Addendum No. 01

Project: New Police Station
City of Lacey
222 College Street SE
Lacey, WA 98503
City Project No. PW 2022-13

Issue Date: October 16, 2023

10 COUNTER TOP AT OPEN BASE @ CMU WALL
1" = 1'-0"

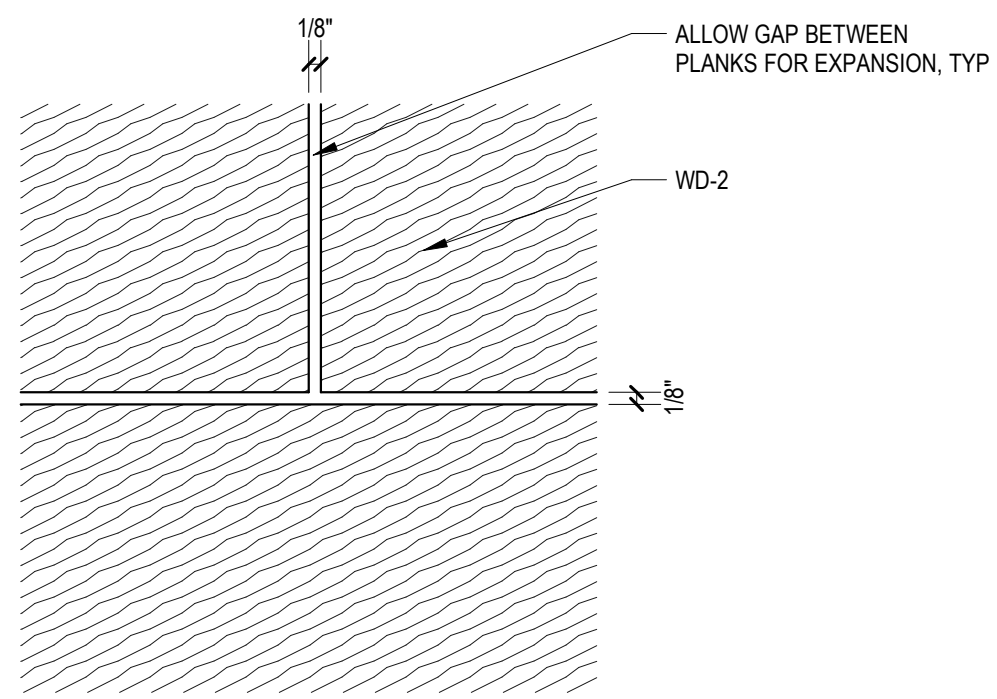
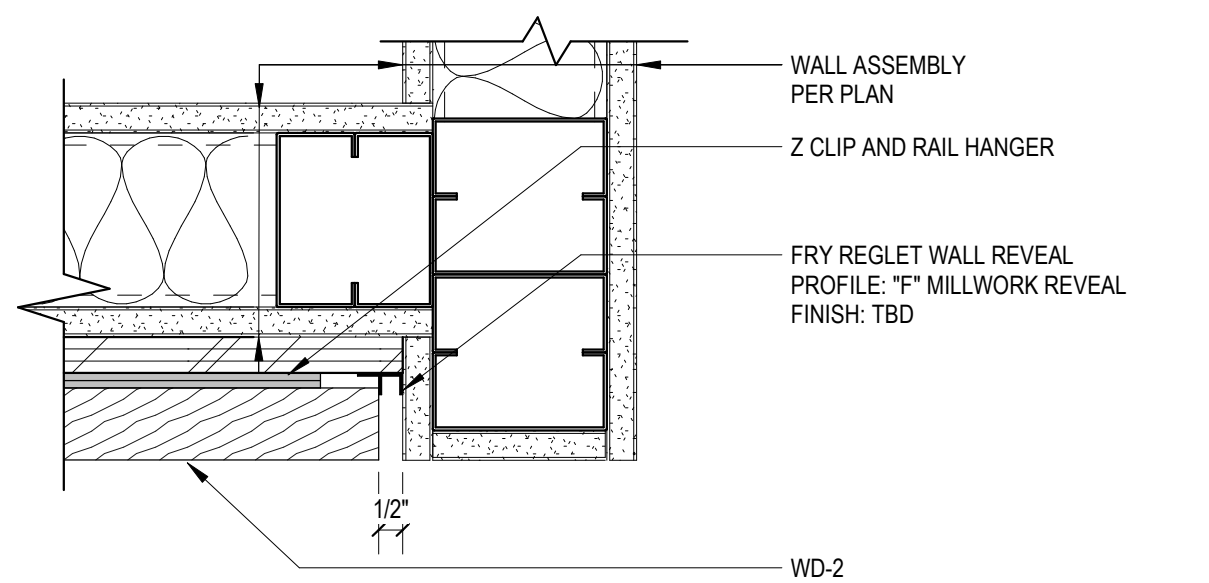
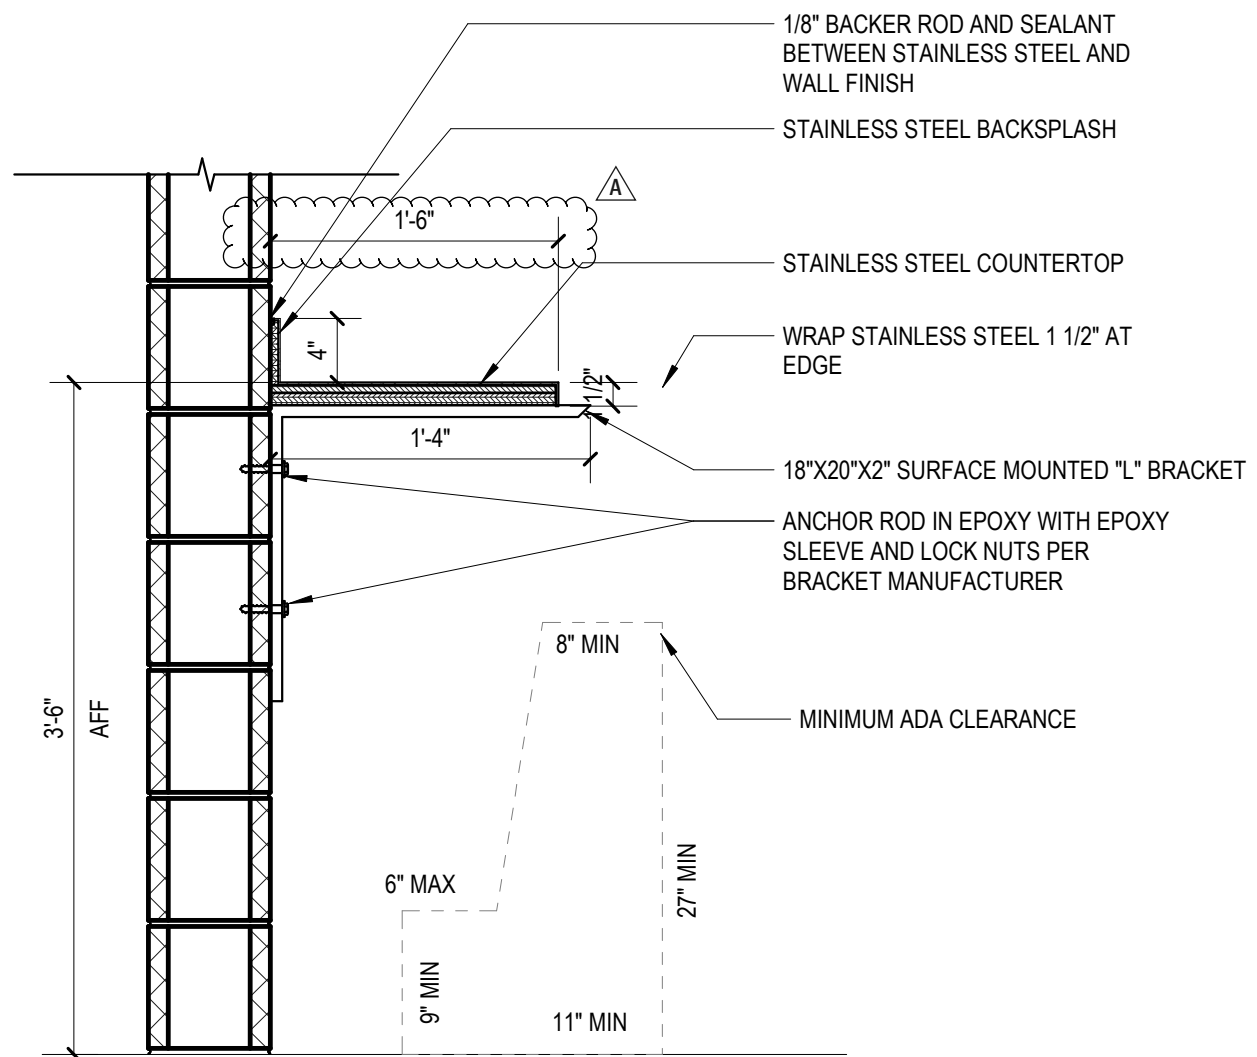
- 1) Detail view 10: revise dimension of stainless steel countertop to 1'-6" per 11x17 sheet A-583-A1 attached to this Addendum.
- 2) Add detail 11 per 11x17 sheet A-583-A1 attached to this Addendum.
- 3) Add detail 12 per 11x17 sheet A-583-A1 attached to this Addendum.
- 4) Add detail 13 per 11x17 sheet A-583-A1 attached to this Addendum.

M-122-A1

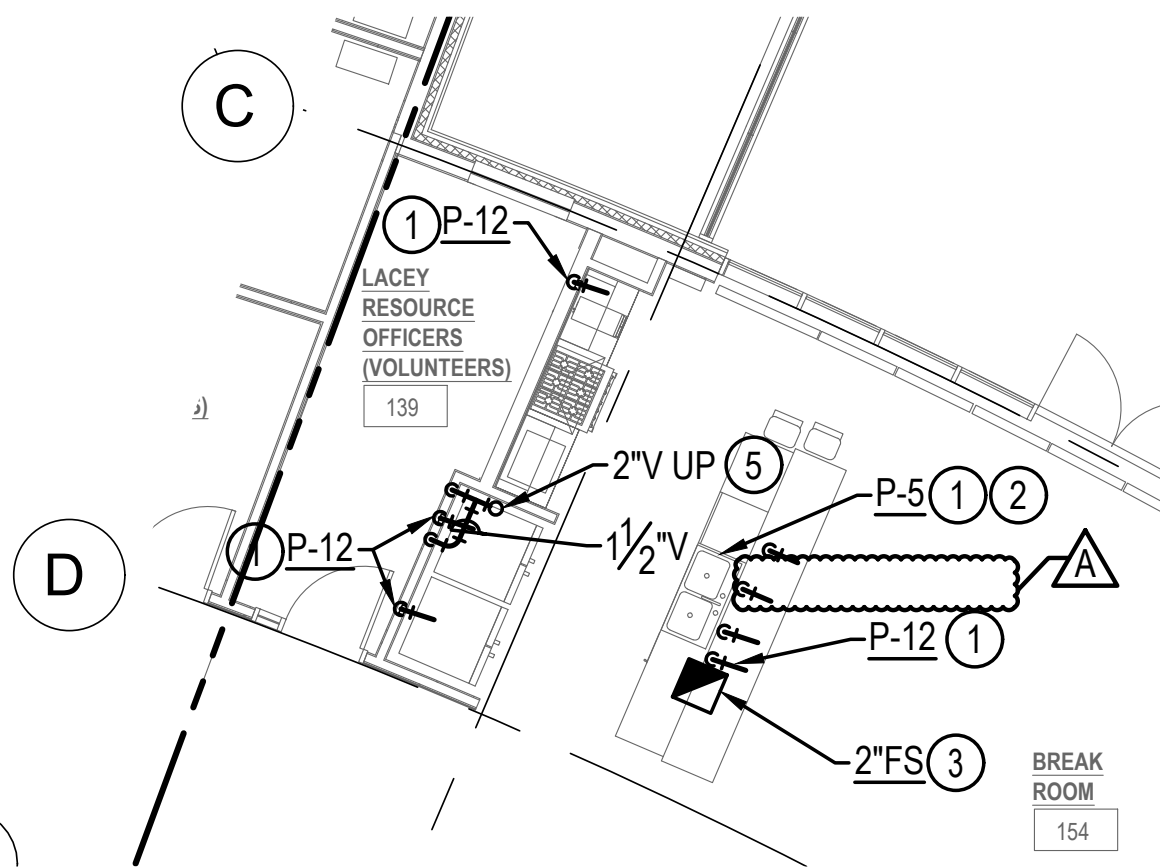
- 1) Revise construction note 8 to read: “ 1/2-INCH AIR COMPRESSOR AIR DROP FED FROM MECHANICAL ROOM SEE SHEET 5/M-401 FOR CONTINUATION. ”
- 2) Revise plan as shown per 8.5x11 sheet M-122-A1 attached to this Addendum.

6 ROOM 168 AND 176 SECTION
1/4" = 1'-0"

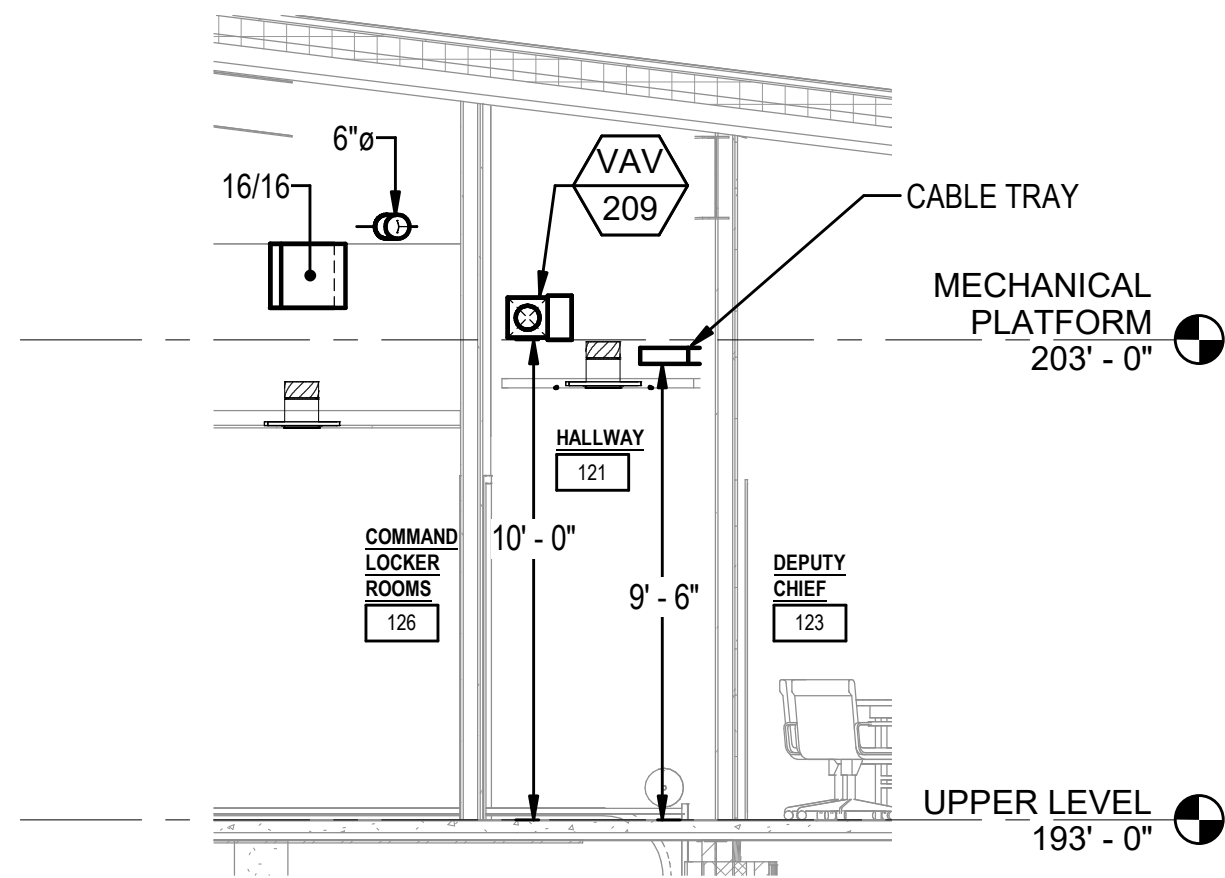
- 1) Add detail view 6, ROOM 168 AND 176 SECTION per 11x17 sheet M-403-A1 attached to this Addendum.
- 2) Add detail view 7, HALLWAY 121 SECTION per 11x17 sheet M-403-A1 attached to this Addendum.

1 TRAINING BUILDING FLOOR PLAN - BID ALTERNATES (PARTIAL)
 GI401a 1/16" = 1'-0"

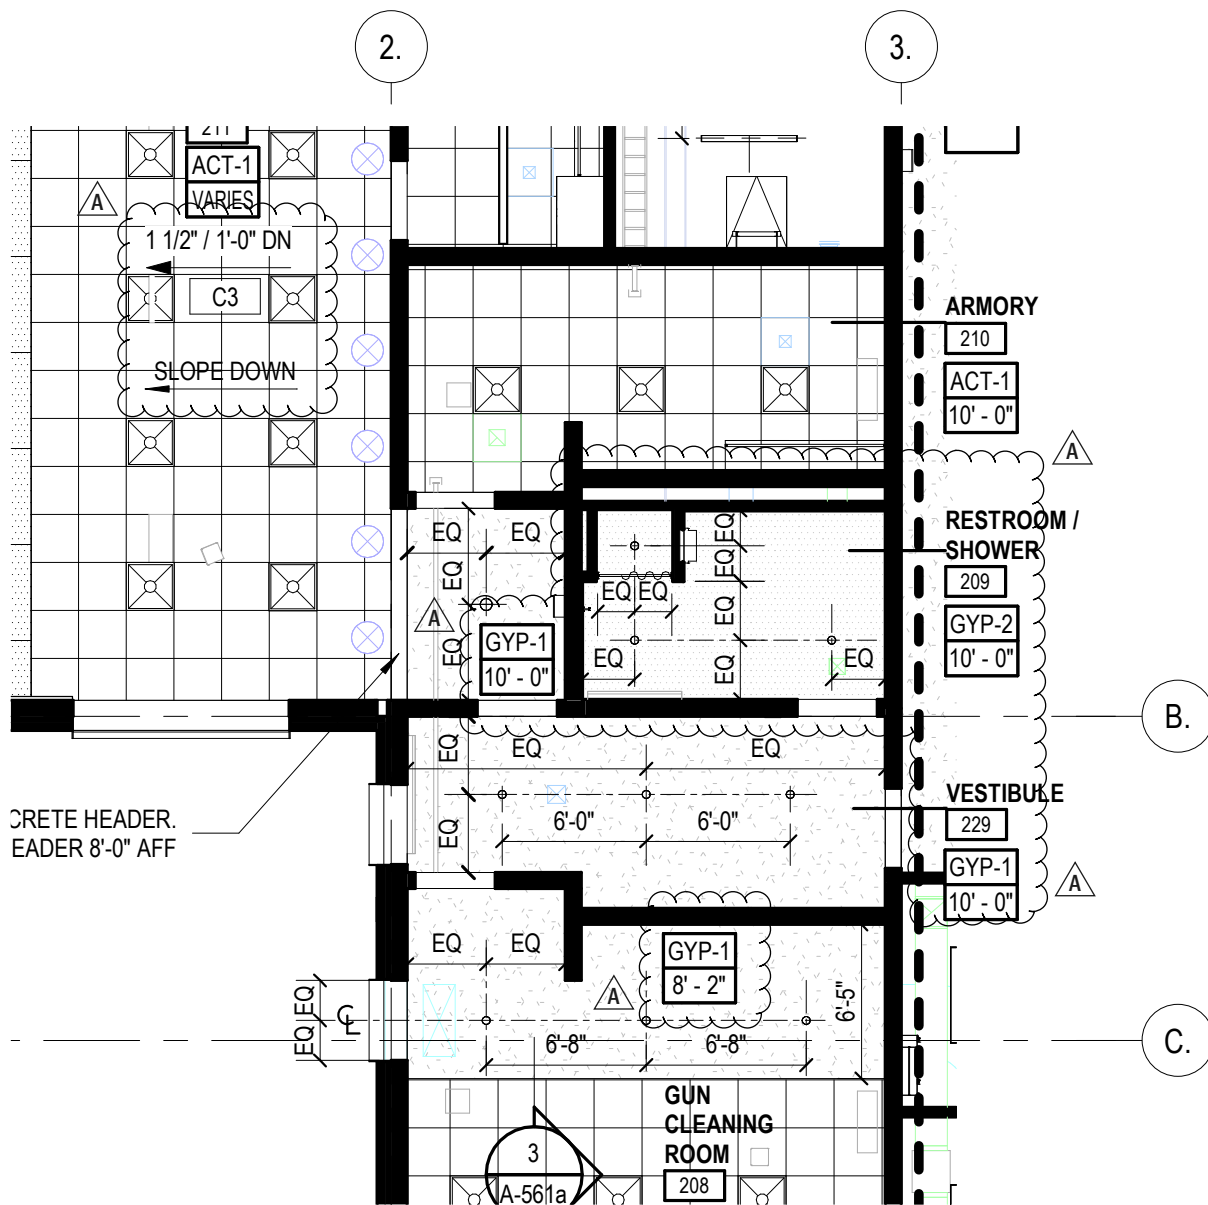
- 1) Bid Alternates Legend: update hatch locations to align and correspond with alternate descriptions per 8.5x11 sheet GI401a-A1 attached to this Addendum.
- 2) Plan view 1, Room 219 Defensive Tactics Training Room: revise hatch to include room as part of ADD ALTERNATE NO. 1C per 8.5x11 sheet GI401a-A1 attached to this Addendum.
